**Camino Real Regional Mobility Authority**

**Fabens Airport Hangar Expansion Project**

**Questions & Answers**

**December 19, 2023**

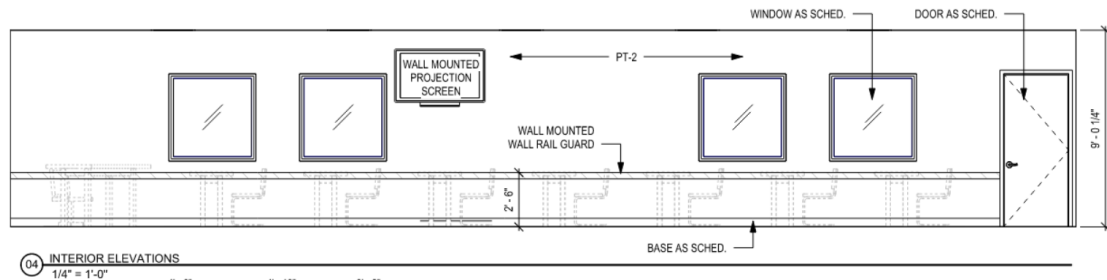
7. Need clarification on the Dimensional Signage. The plans do not reflect what is needed or where. There are specifications for this trade with information on the exterior dimensional letters. For budgetary purposes can I request the following:

HANGER 1  
HANGER 2  
HANGER 3  
HANGER 4  
HANGER 5

Exterior Signage specification will be removed since no dimensional signage is to be installed, please refer to Addendum No. 1 dated December 19, 2023.

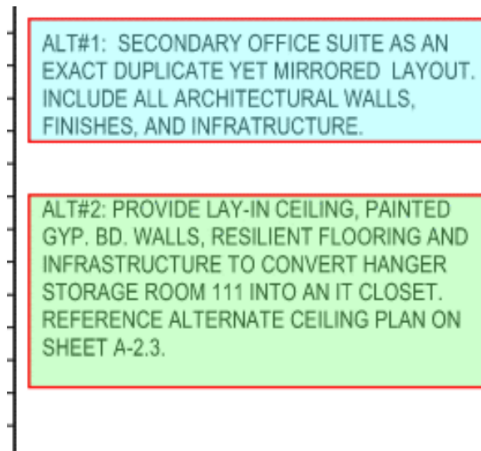
11. Specifications for Visual Display are included but the plans do not reflect Markerboards, Tackboards or Chalkboards. Please provide locations if any

Visual display boards are to be furnished and installed by owner or future tenant. Contractor is to provide wall blocking and coordinate locations with owner.
